ADDENDUM NUMBER 2

1.02 PROJECT: ELMORE GYM ELECTRICAL SERVICE REPLACEMENT

1.03 PROJECT NUMBER: 26239.0, DCM/BC NO. 2023098, PSCA NO. 2082

1.04 OWNER: ALABAMA A&M UNIVERSITY

DRAWING NO. **E2.1**

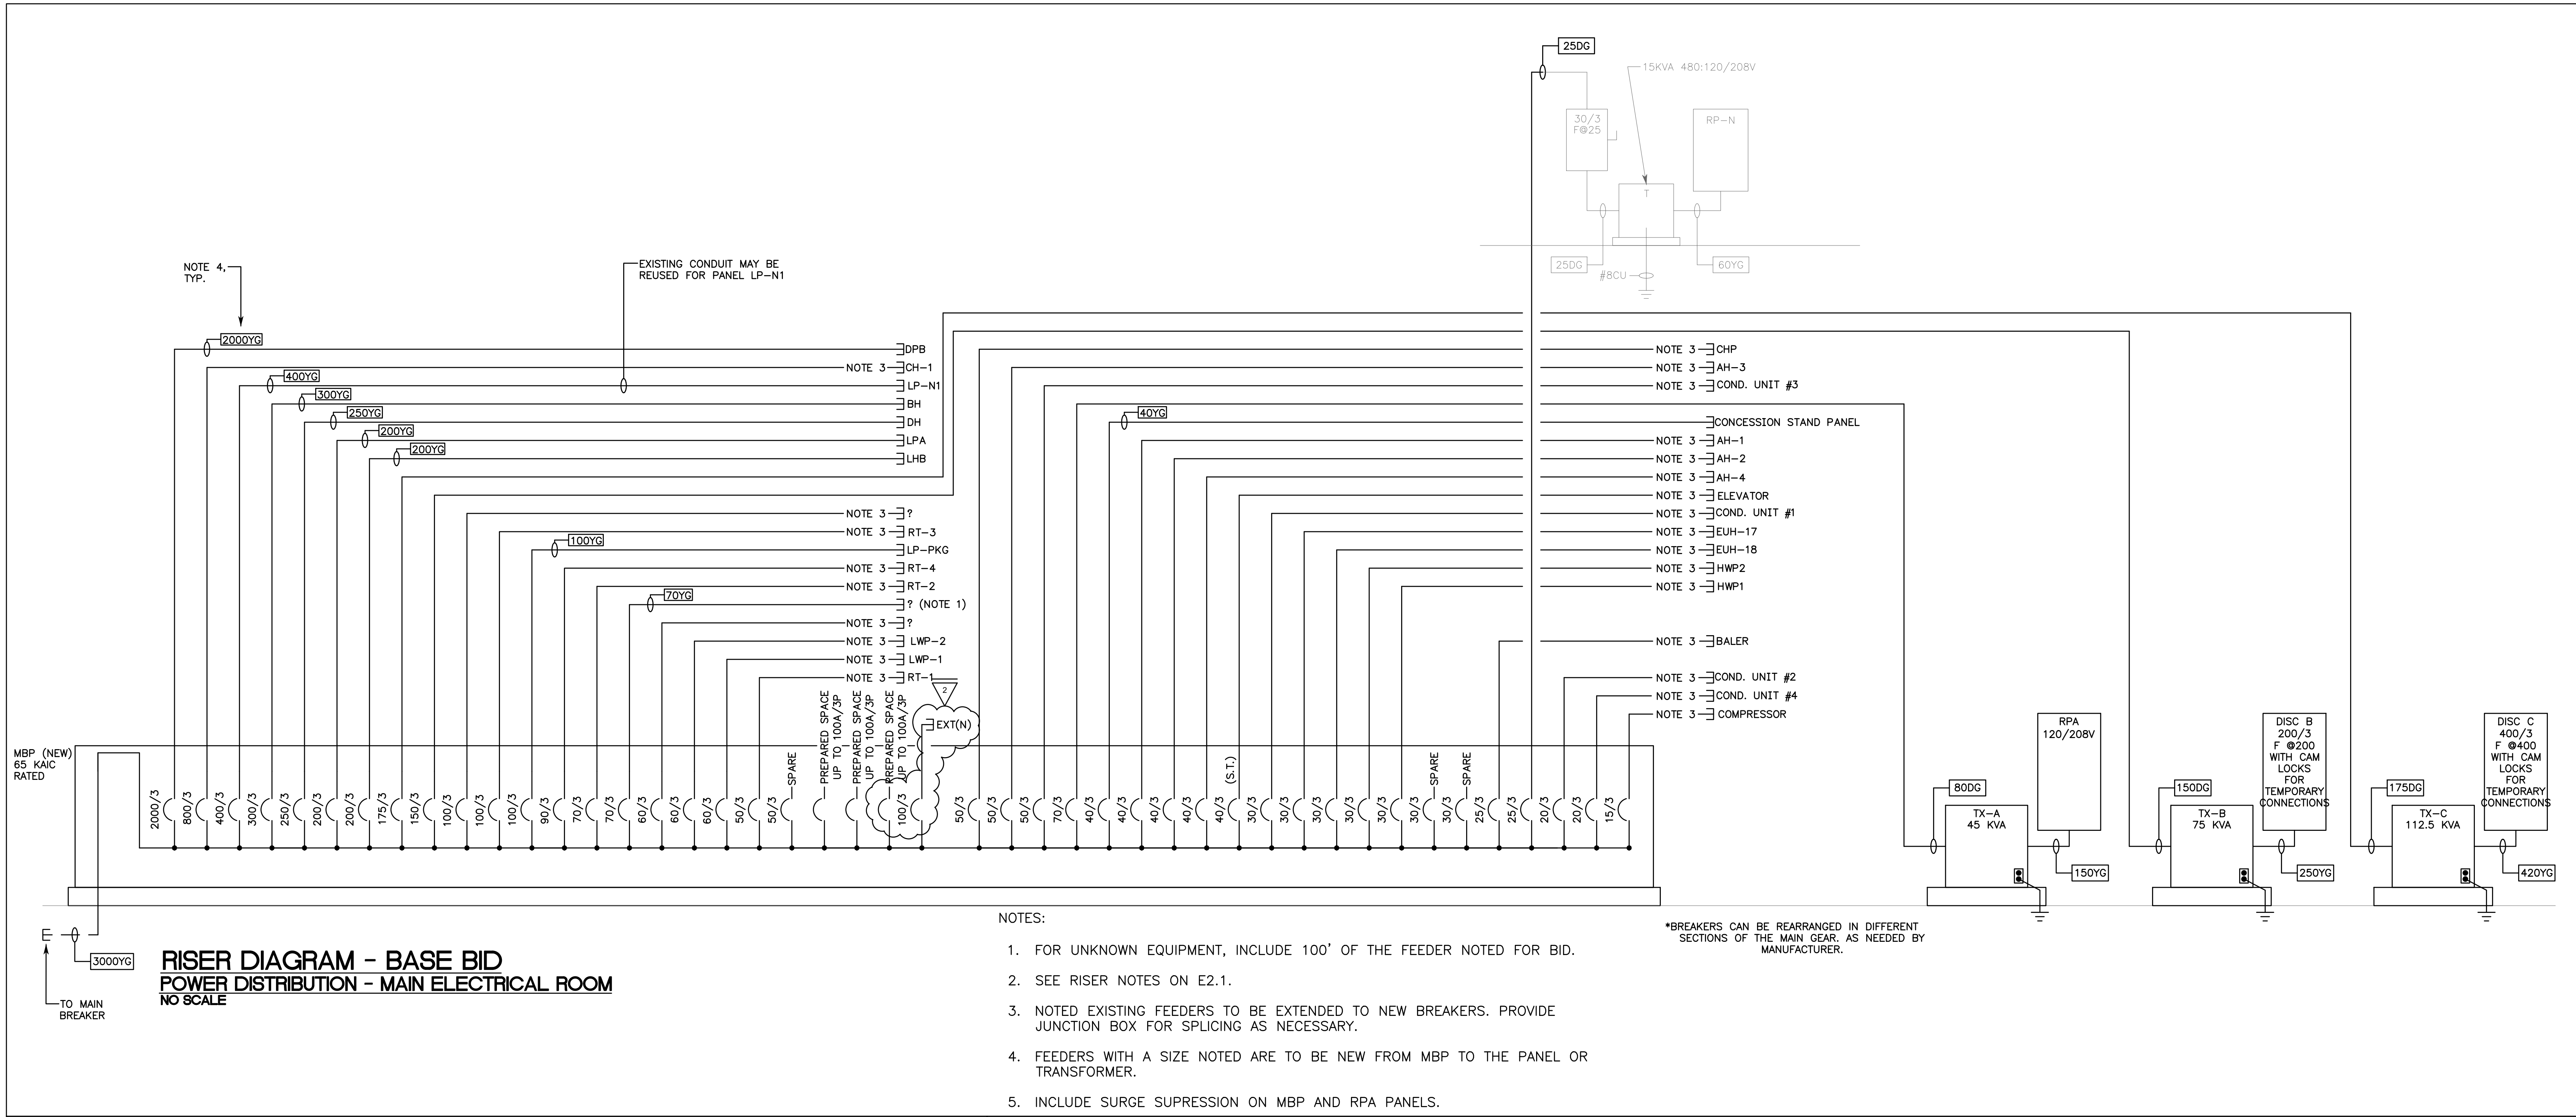
4.02 SHEET E2.1 – PRIMARY RISER, NOTES, AND TRANSFORMER DETAILS

A. Feeder Schedule – Ground Wire size for feeders 2000YG and 3000YG updated.

DATE: 09/29/2023
 JOB NUMBER: 23235.0
 DRAWN BY: BR
 CHECKED BY: MBR
 DRAWING TITLE: RISER DIAGRAMS
 DRAWING NO.: E2.2

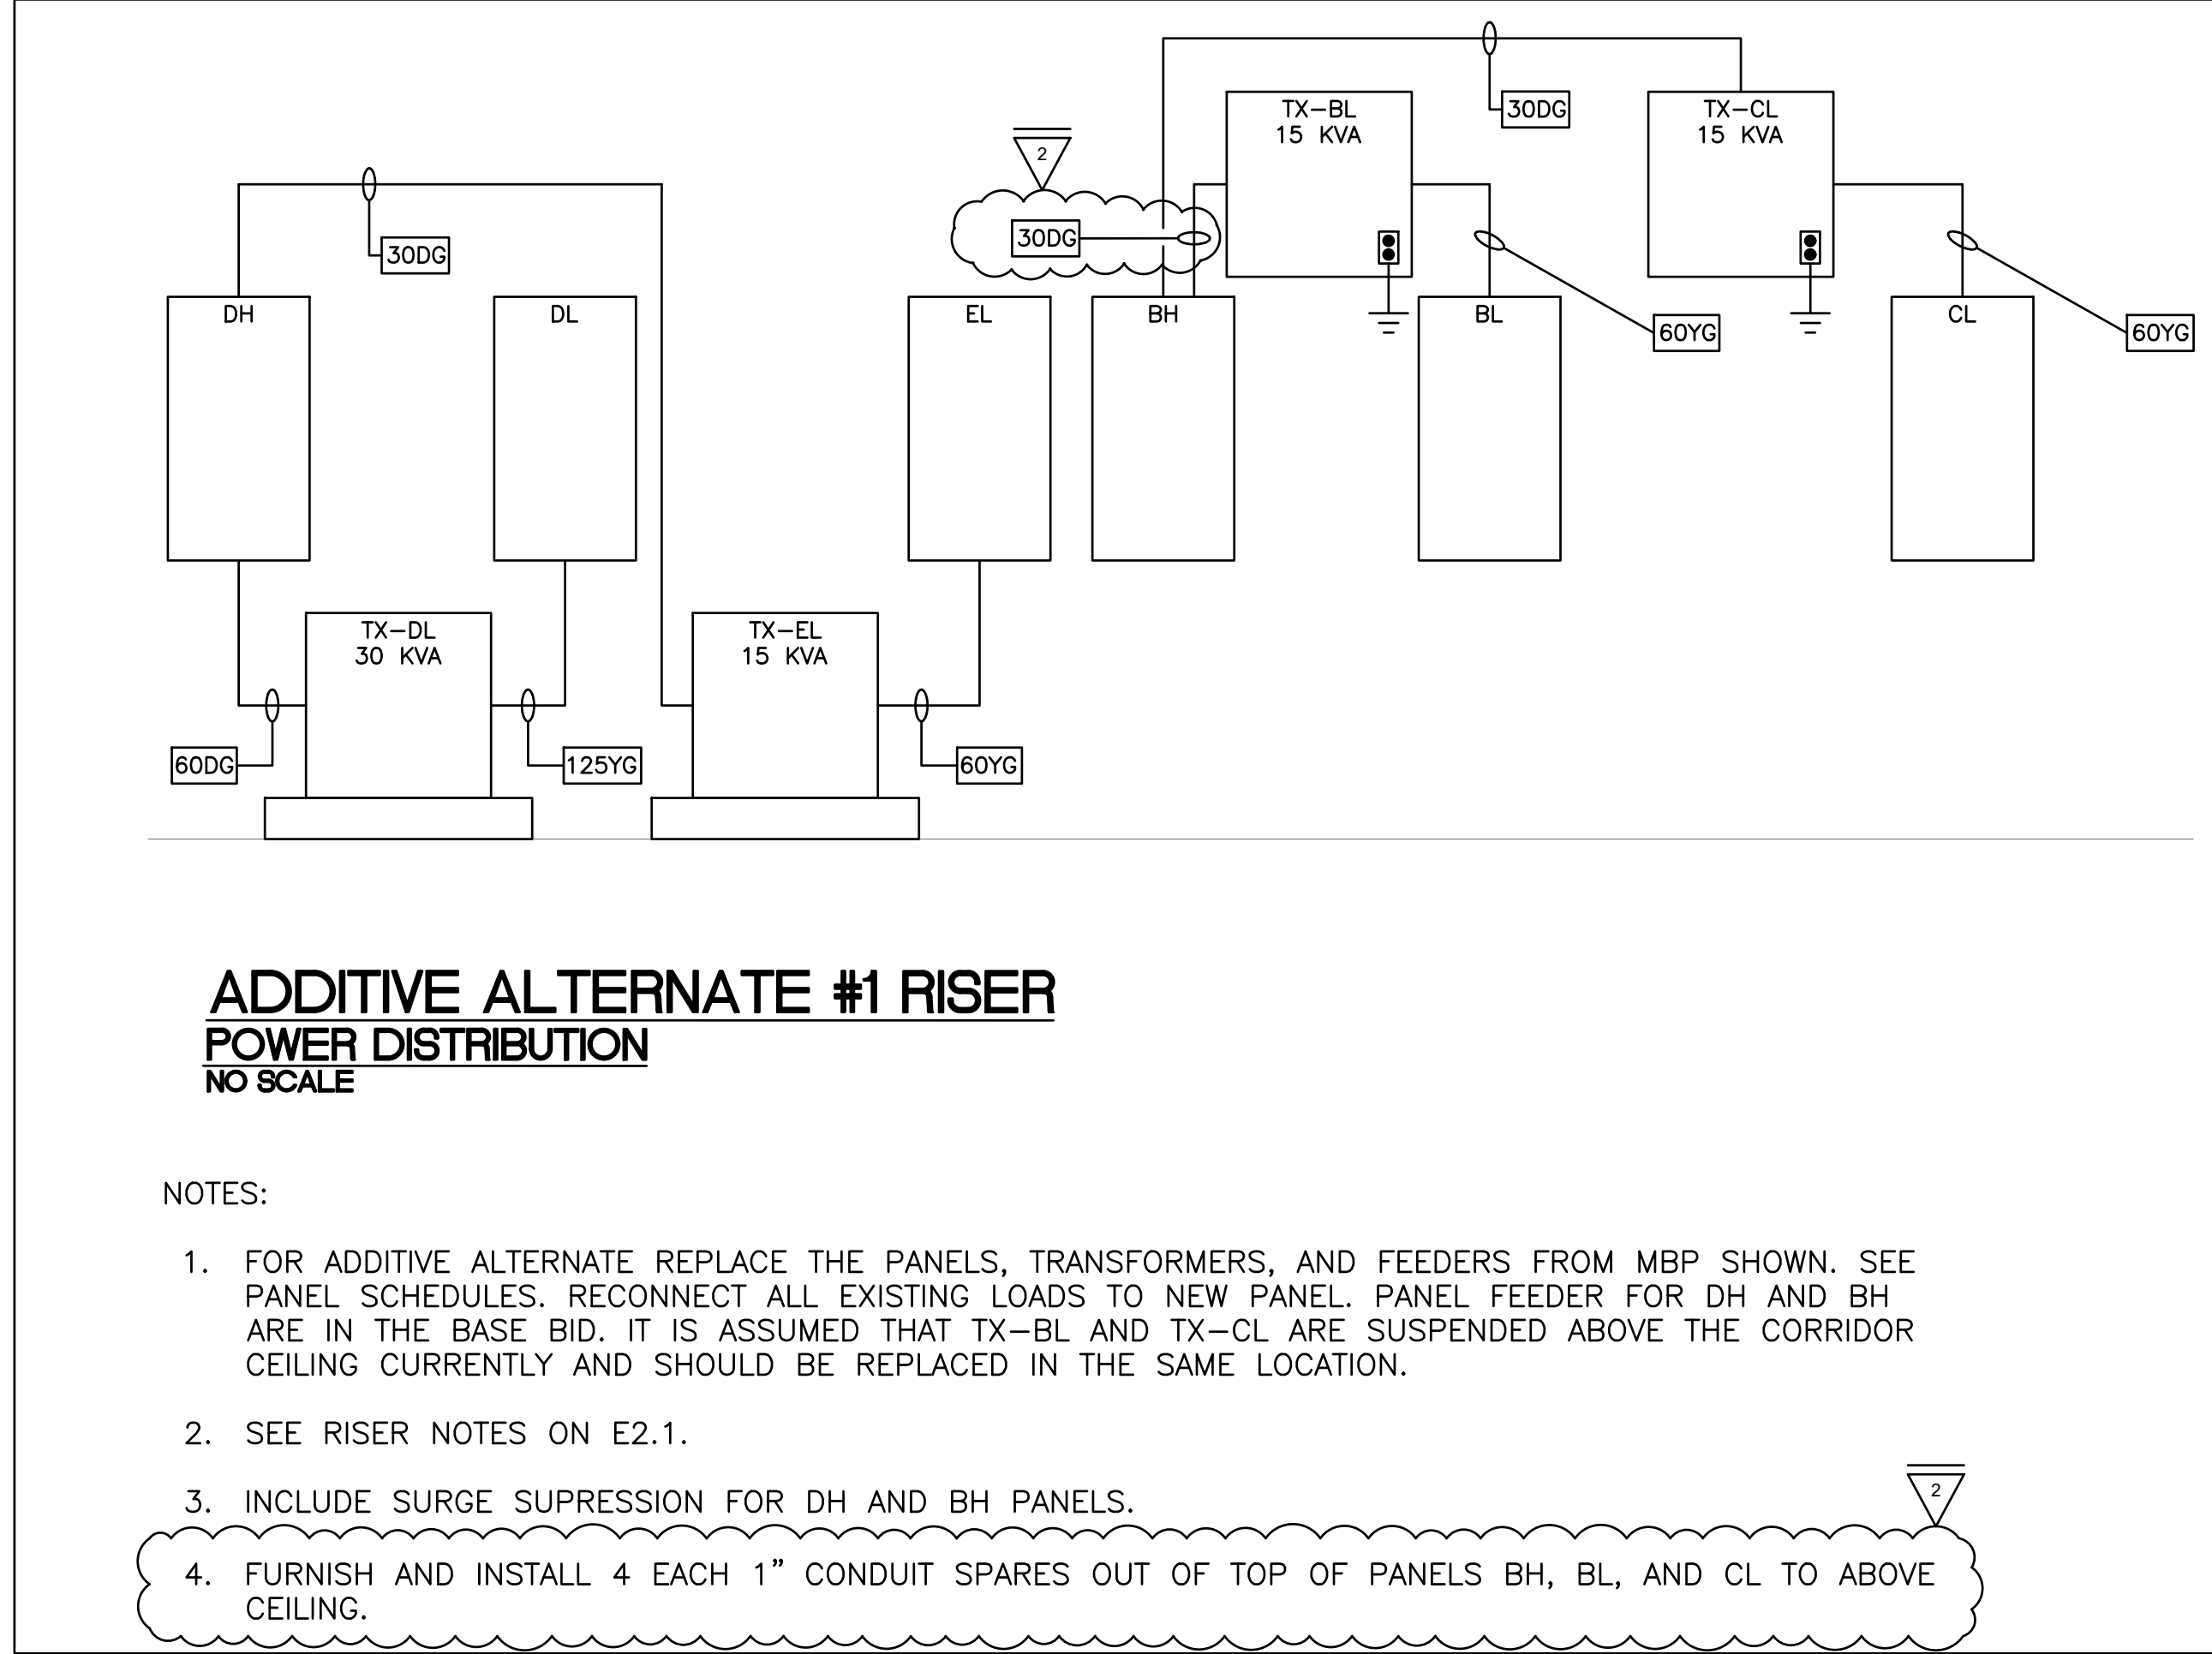
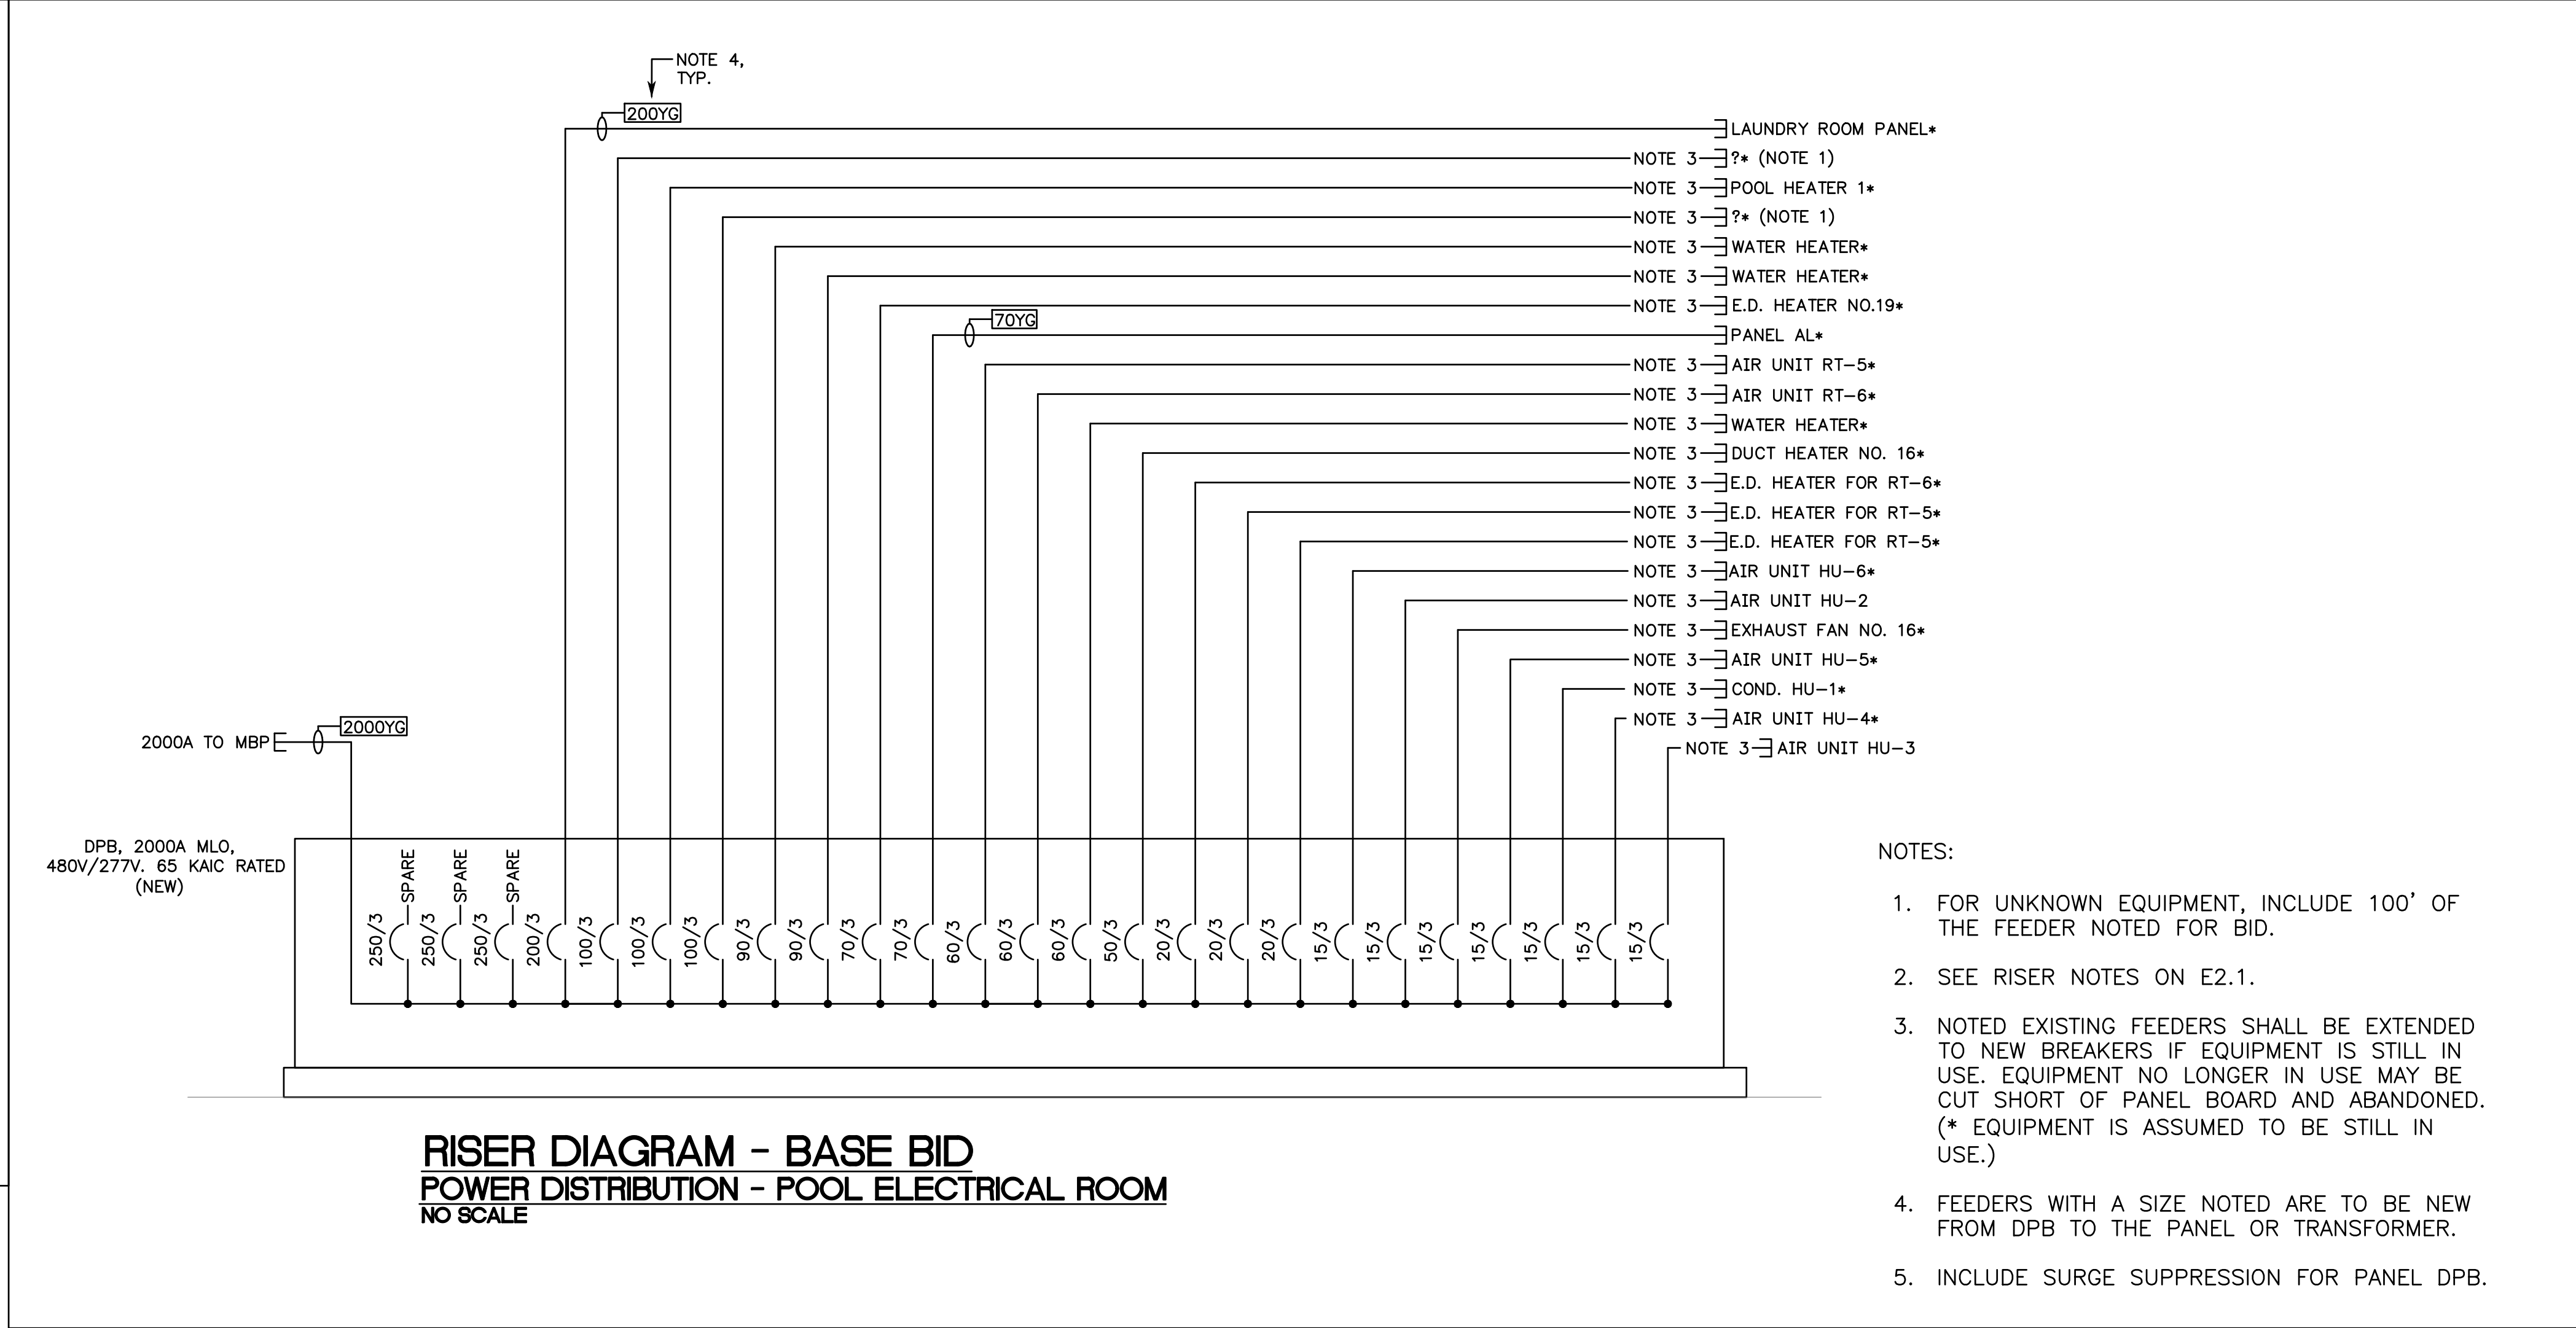
4.03 SHEET E2.2 – RISER DIAGRAMS

A. Riser Diagram – 100A/3P breaker added to MBP for panel EXT (N).

B. Additive Alternate #1 Riser – 30DG feeder added to drawing and Note 4 added.
